**Subject: Amended MHI's Responses to US-APWR DCD RAI No. 71-986 Revision 0 (SRP 03.06.02)**

Amended Response to Request for Additional Information No. 71-986  
Revision 0

**RAI NO.: NO. 71-986 REVISION 0**

**SRP SECTION: 03.06.02 - DETERMINATION OF RUPTURE LOCATIONS AND  
DYNAMIC EFFECTS ASSOCIATED WITH THE POSTULATED  
RUPTURE OF PIPING**

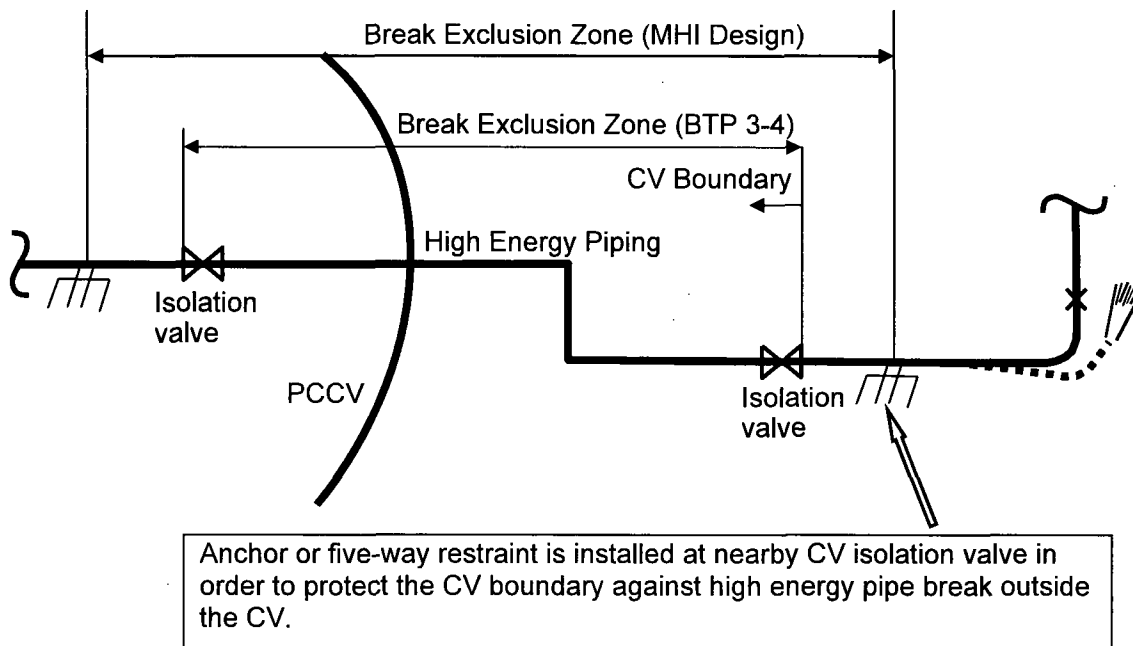
- (b) DCD Section defines the break exclusion area from the PCCV penetration to an anchor or five-way restraint, while BTP 3-4 defines this from containment wall to and including the inboard or outboard isolation valves. Explain, possibly with sketches, how the DCD definition of the break exclusion area includes both inboard and outboard isolation valves or confirm that the break exclusion area includes only the outboard valves within the main steam pipe room, as shown in DCD Figure 3.6-1. Also, if the break exclusion region defined in the DCD is beyond the outboard isolation valve, justify the differences between the DCD criteria and the staff position in BTP 3-4.

- (a) There is no Class 1 piping in PCCV penetration area (piping from PCCV penetration wall to and including the inboard or outboard isolation valves).
- (b) In the MHI design practices applicable to Japanese PWR plants, as described in DCD Subsection 3.6.1.2.3.3, an anchor or five-way restraint is located as close as practical to the containment isolation valves inside and/or outside of the PCCV to assure operability of the isolation valve and preserve the integrity of the PCCV penetration area. MHI design practices therefore include a break exclusion zone between the isolation valve inside and/or outside of the PCCV and the anchor point or five-way restraint, which is different than the break exclusion zone defined in BTP 3-4. Refer to RAI 71-986 Question No. 03.06.02-2, Appendix A, for a summary of MHI break exclusion zone design practices applicable to Japanese PWR plants.

If it is not acceptable to apply the break exclusion zone between the isolation valve and anchor or five-way restraint, a piping design without an anchor or five-way restraint close to the isolation valve will be implemented to preclude the anchor or five-way restraint from being postulated as a pipe break point.

In recognition of the RAI comment, MHI design practices applicable to Japanese PWR plants will therefore not be applied to the US-APWR. The pipe break exclusion zone is limited to those portions of piping from the PCCV penetration wall up to and including the inboard or outboard isolation valves as described in BTP 3-4.
